MEETING AGENDA

CITY OF BEAUFORT - HISTORIC DISTRICT REVIEW BOARD

Wednesday, May 13, 2026, 2:00 P.M.

Item No. 2: Removal of entrances and external staircases as well as addition of fenestration (East elevation)

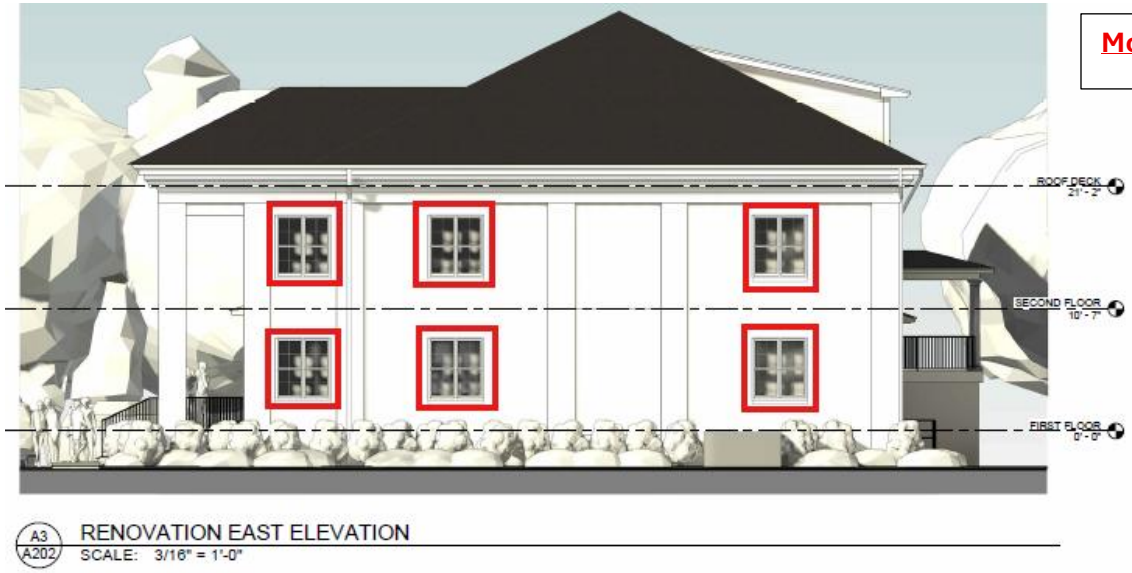
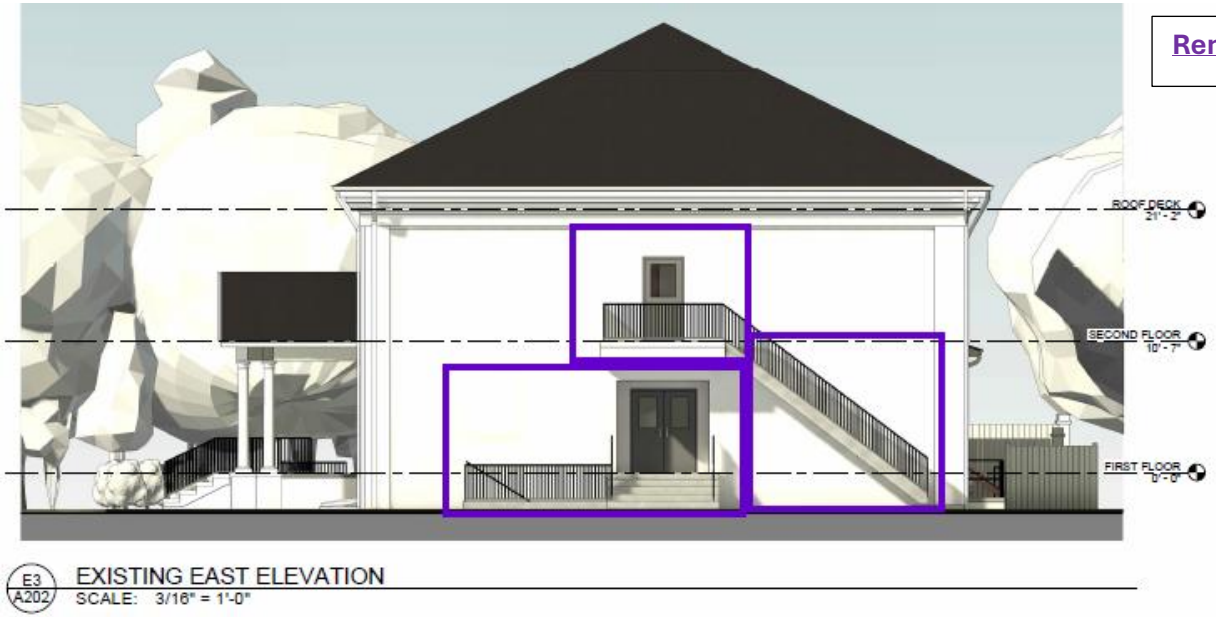
STAFF ANALYSIS:

Modifications - new (West façade)

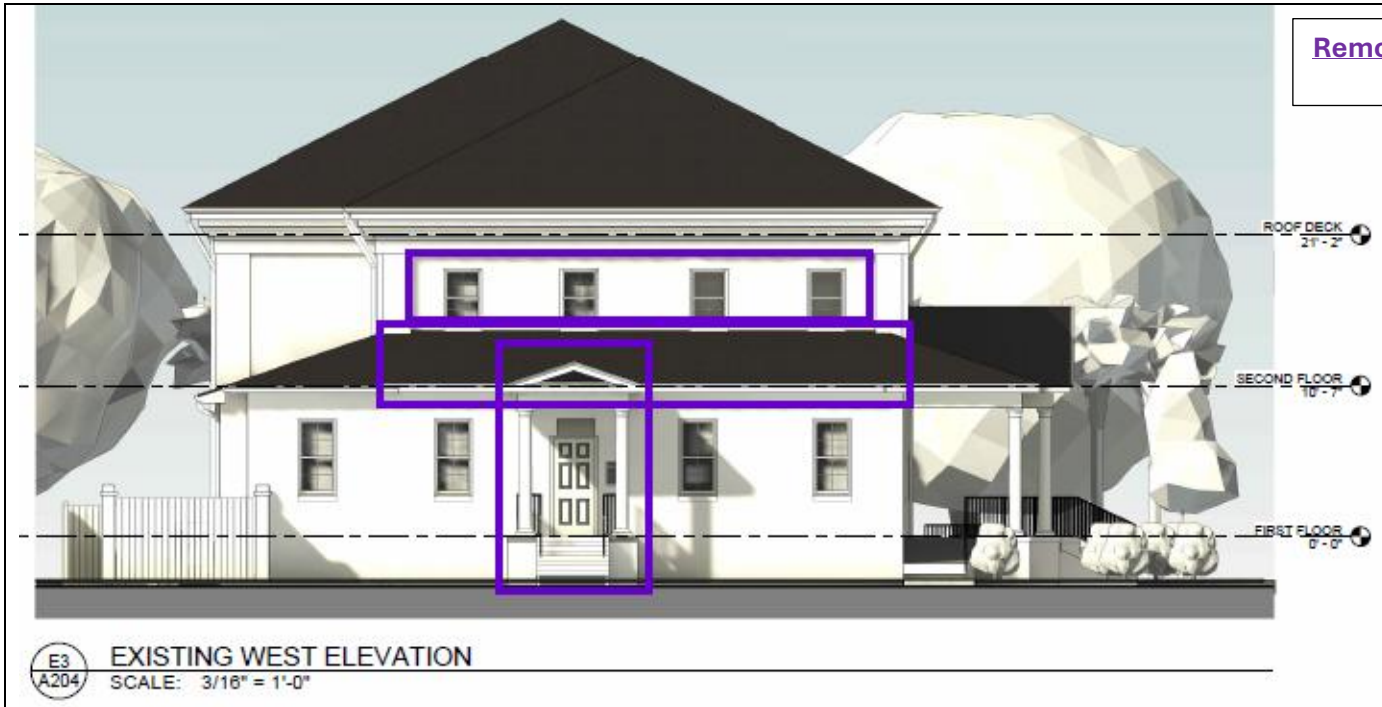
- Existing first-floor side entrance together with small gabled roof to be removed.
- Also, existing shed roof that wraps around from front (south) façade on first floor to be removed/discontinued on side.
- Installation of new window where door was and also same size windows on second floor to create uniformly scaled fenestration.
  - ➢ Staff is supportive of creating uniform fenestration and an overall less busy façade on this west side of the building.
